CERTIFICATE OF APPROPRIATENESS

Property: 1641 Columbia Street, lot 3, block 114, Houston Heights Subdivision. The property includes a historic 1,328 square foot, one-story wood frame single-family residence situated on a 6,600 square foot (50' x 132') interior lot.

Proposal: Alteration – Relocate the one-story 1,330 square foot contributing residence forward to 20' front setback. Brick porch columns and wing walls will be disassembled with care and reinstalled to match original conditions at the new location. Any damaged brickwork to be verified by staff and replaced in kind. The existing asbestos siding will be removed to expose the original 117 siding. Post relocation, a two-story 2,800 square foot addition with attached garage will be constructed. Addition will measure 41'-6" wide and 60'-3" deep overall. The roof of an existing side addition will be extended to tie in to the proposed addition. The one-story portion of the addition will have an eave height of 10'-1" and a ridge of 22'-4"; the two-story portion will have an eave height of 20'-4" and a ridge height of 27'-4".

SOUTH SIDE ELEVATION

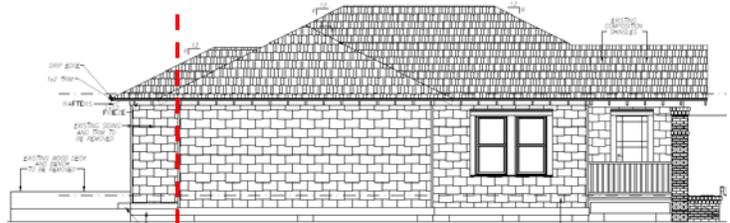
1641 Columbia - Oppose. First, it appears on the plans as if the south side of the original roof is being raised. If so, this does not meet criteria and should not be allowed, a change such as this would significantly alter the existing historic structure. Second, the proposed relocation is not in keeping with the historic setbacks of that block. Sanborn maps clearly show the original setbacks and allowing a relocation based on the reasoning that staff provided sets a precedence that is far overreaching. Historic documents provide enough information to assert that the existing setback should remain.

FRONT WALL BLOCKFACE COMPARISON
SANBORN FIRE INSURANCE MAP 1924-1950

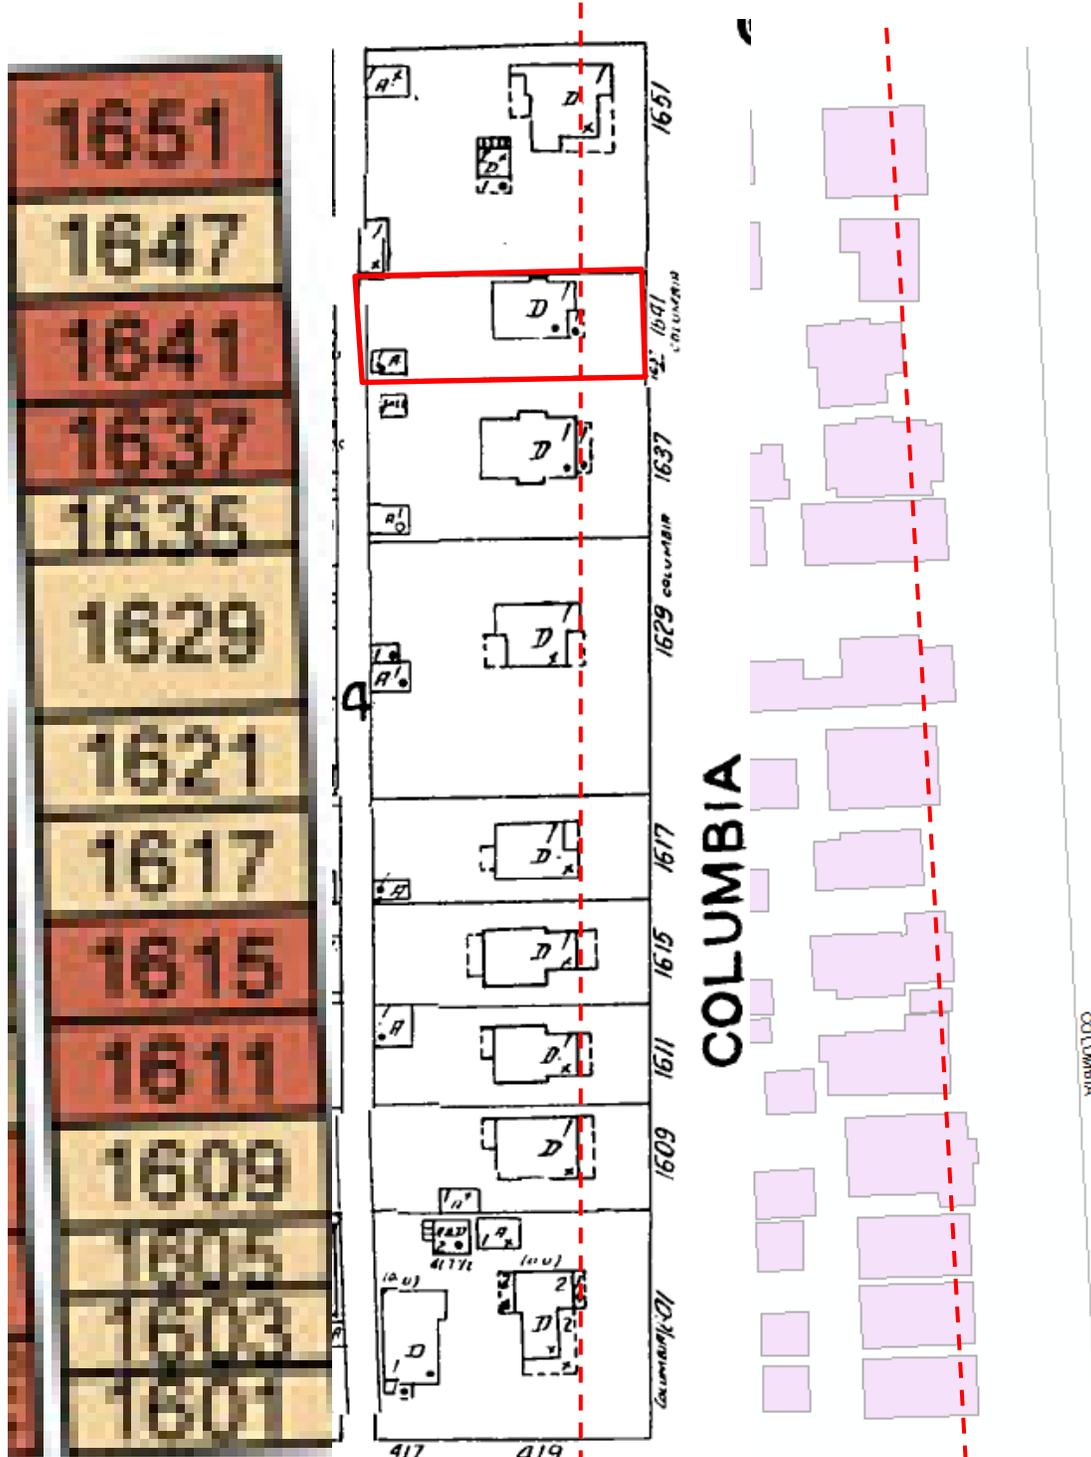
Agenda Item B18 (1641 Columbia): OBJECT – The movement of this existing contributing structure should not be allowed. The 1600 block of Columbia has very little remaining historic character as most of the residences were rebuilt before the District was created. The Houston Heights subdivision plat has no front building setback and the default setback has been 10 feet. If we allow existing contributing structures to be moved on the property, we could end up with only a 10 foot setback throughout our District, which is not supported by the historical setbacks of a deeper distance from the street. Allowance of the movement of this structure, even though it is still 20 feet back will open the door for every applicant to request a 10 foot setback on any lot in our District and not within a Prevailing Building Setback protected block which would be highly detrimental to the historical look of the HHEHD.
